APPEAL SUMMARY

<b>Appeal ID:</b> 25057	<b>Project Address:</b> 321 NE Davis St
<b>Hearing Date:</b> 8/11/21	<b>Appellant Name:</b> Mark Annen
<b>Case No.:</b> B-010	<b>Appellant Phone:</b> 5032394834
<b>Appeal Type:</b> Building	<b>Plans Examiner/Inspector:</b> Sloan Shelton
<b>Project Type:</b> commercial	<b>Stories:</b> 1 <b>Occupancy:</b> F-1, B, S <b>Construction Type:</b> V-B
<b>Building/Business Name:</b> Roseline Coffee	<b>Fire Sprinklers:</b> No
<b>Appeal Involves:</b> Alteration of an existing structure, occ Change from F-1 to B	<b>LUR or Permit Application No.:</b> 21-051511-CO
<b>Plan Submitted Option:</b> pdf [File 1]	<b>Proposed use:</b> Cafe and Roastery

WAREHOUSE TENANT IMPROVEMENT FOR ROASTER, CAFE AND OFFICES  
**ROSELINE COFFEE**  
 321 NE DAVIS ST., PORTLAND, OREGON 97232

APPEAL PARAPET

**AP.1**

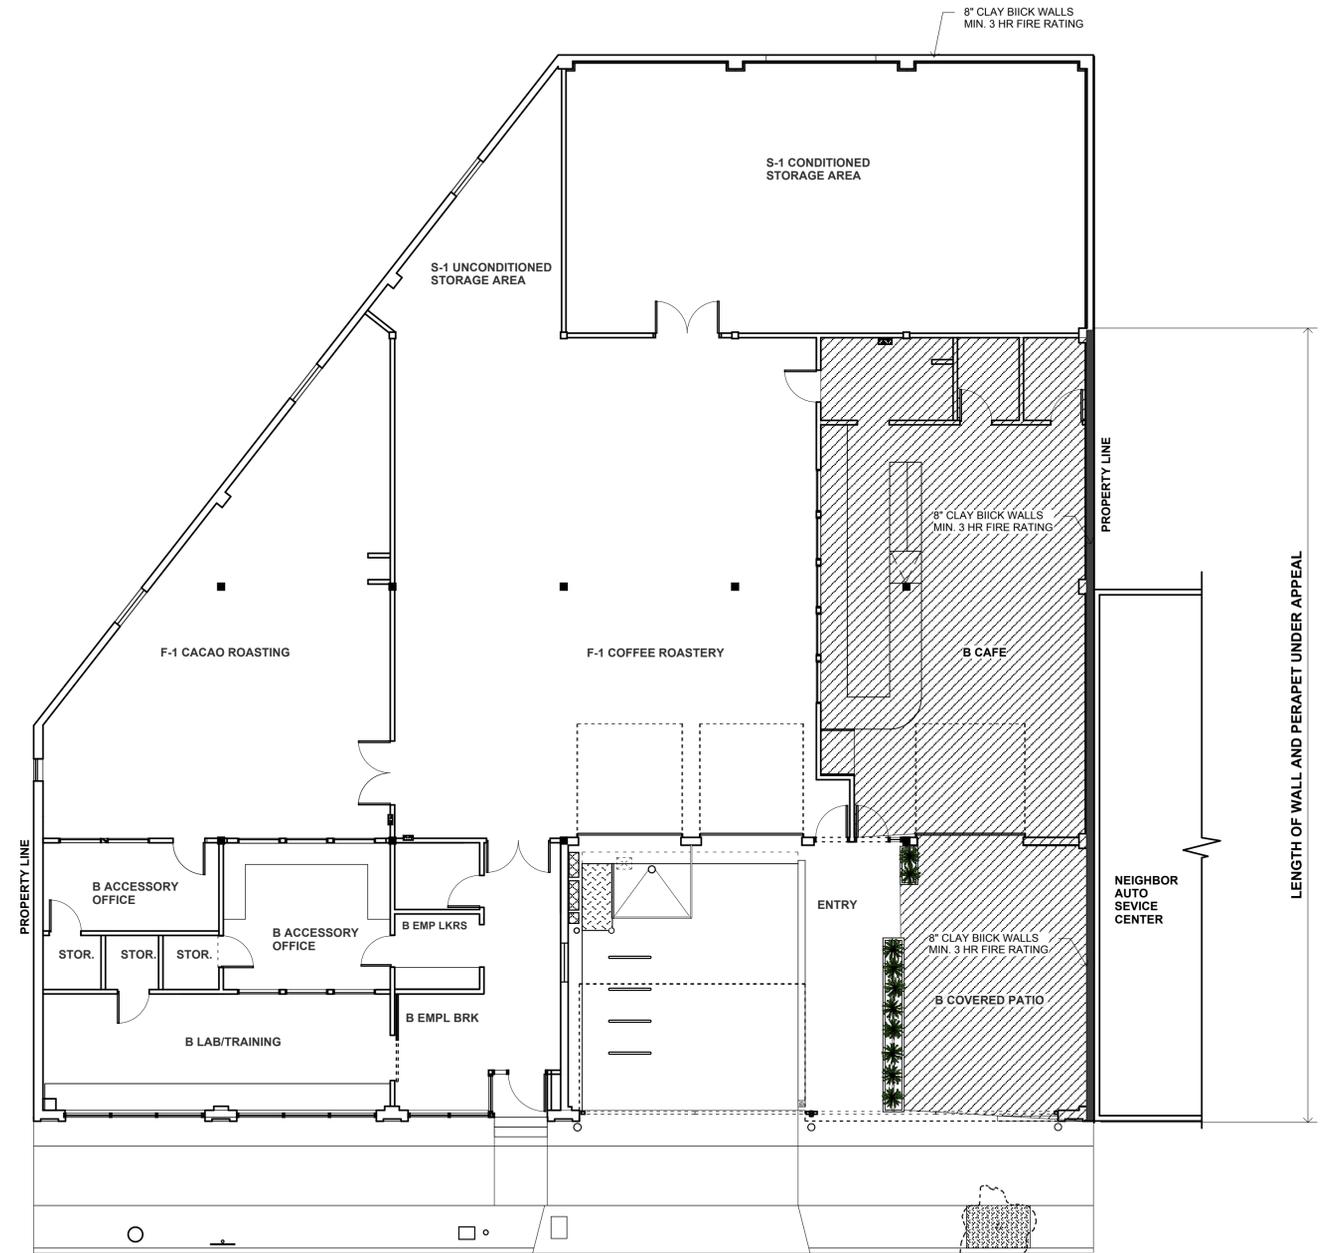
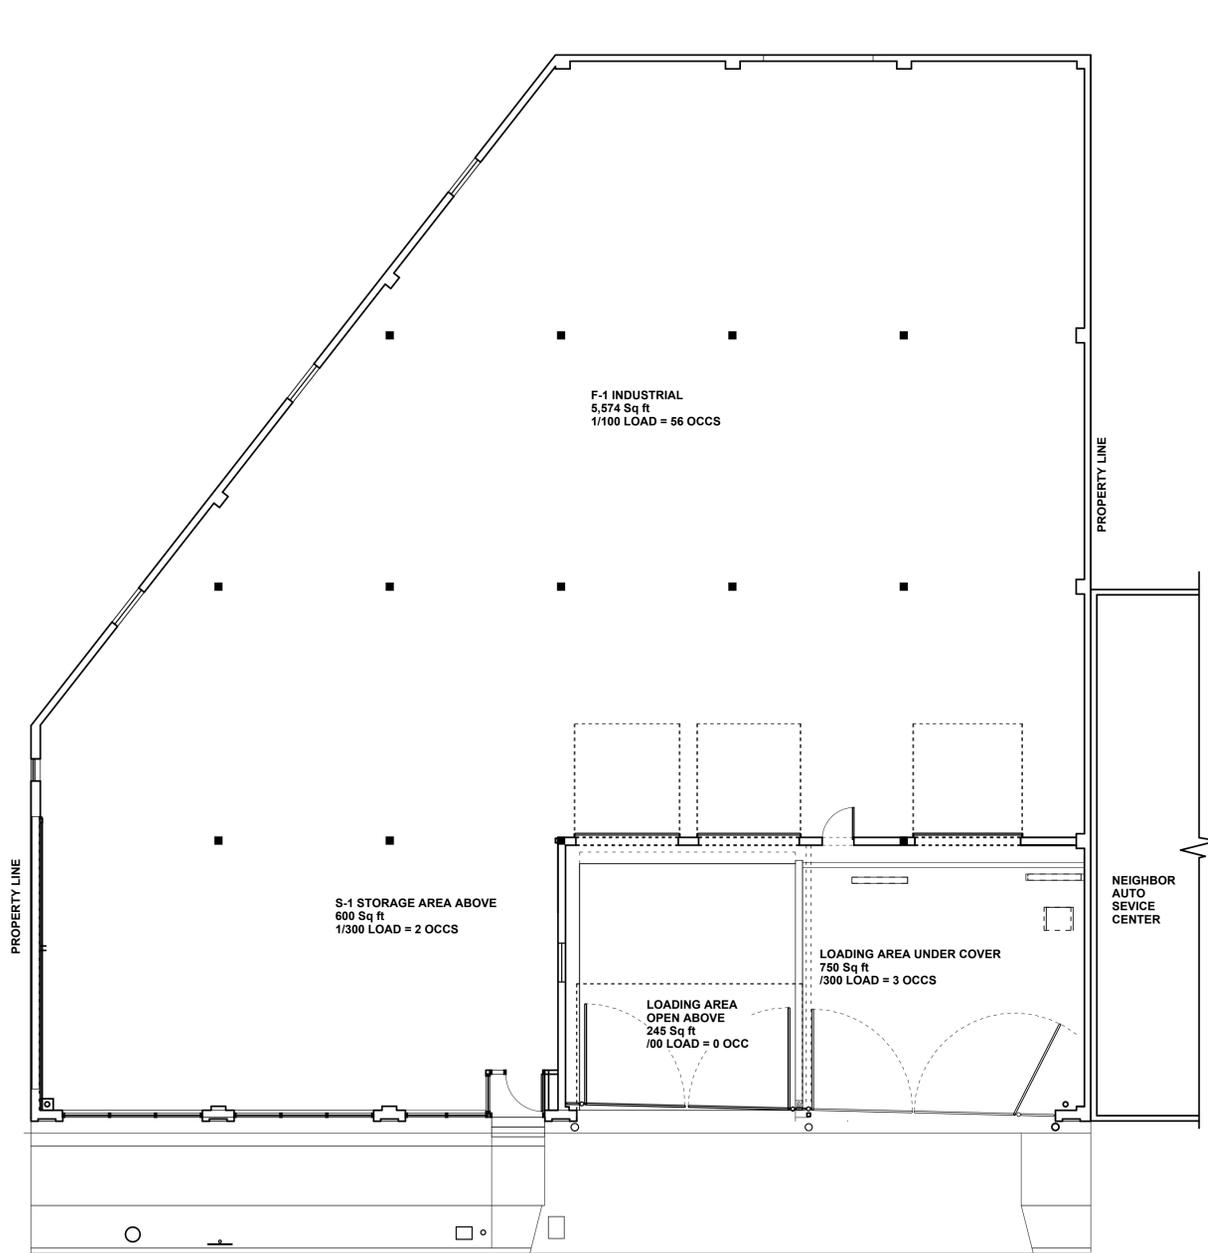
**Code Modification or Alternate Requested** The existing parapet measures 18" to 24" from the sloped roof. No work is being proposed to any portion of the existing roof as part of the scope of work.

**Proposed Design** Wall assembly is 8" brick with a minimum of 3 hour fire rating with existing parapet 24" to 18" above roof.  
The requirement to bring the parapet into conformance is being triggered by the change of occupancy. We are proposing to keep the parapet condition as currently built since there is a decrease in relative hazard and no work is proposed to any portion of the roof this scope of work.

### **Change of occupancy from F1 to B with existing East parapet to remain: Granted as proposed for this use and occupancy.**

**4. AERIAL VIEW OF PARAPET LOOKING EAST**

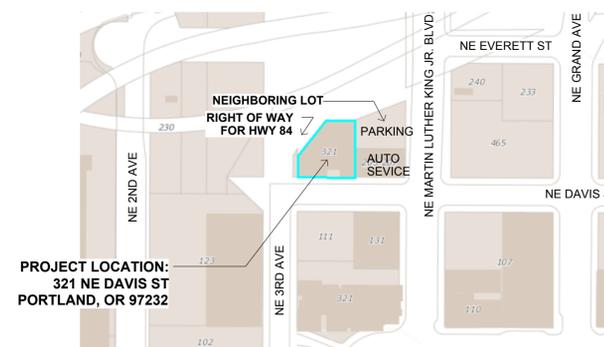
The east exterior wall is constructed with 8" thick clay brick which spans full height from grade to top of parapet and meets the required minimum 1 hour rating outlined in table 721.1(2), material 1-1.1. This meets the intent of the parapet having the same fire resistance as required for the supporting wall.
